Changes to the LCD (Display Device), Power Consumption, and Compatible GT Designer3 (GOT2000) Versions for the GT2103-PMBDS for Markets Outside Japan

GOT2000 Series

GOT-A-0296-A

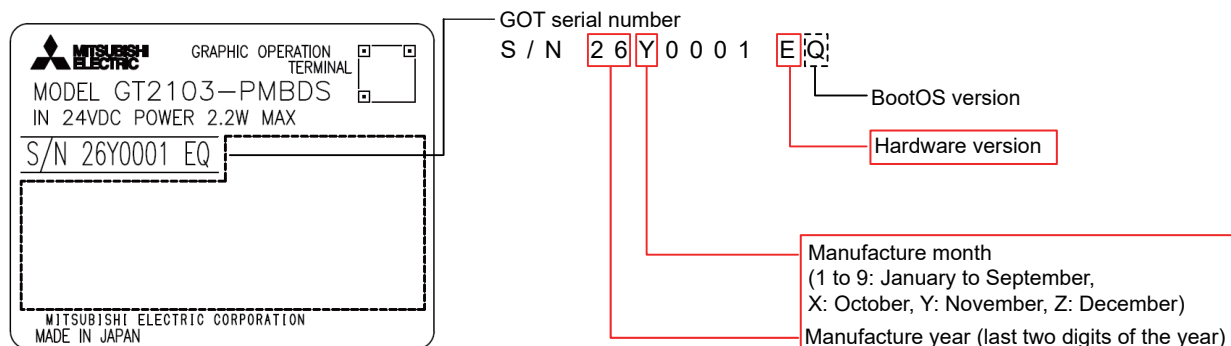
GT Designer3 (GOT2000) versions earlier than 1.325P cannot be used with the updated hardware version E.

Use GT Designer3 (GOT2000) version 1.325P or later.
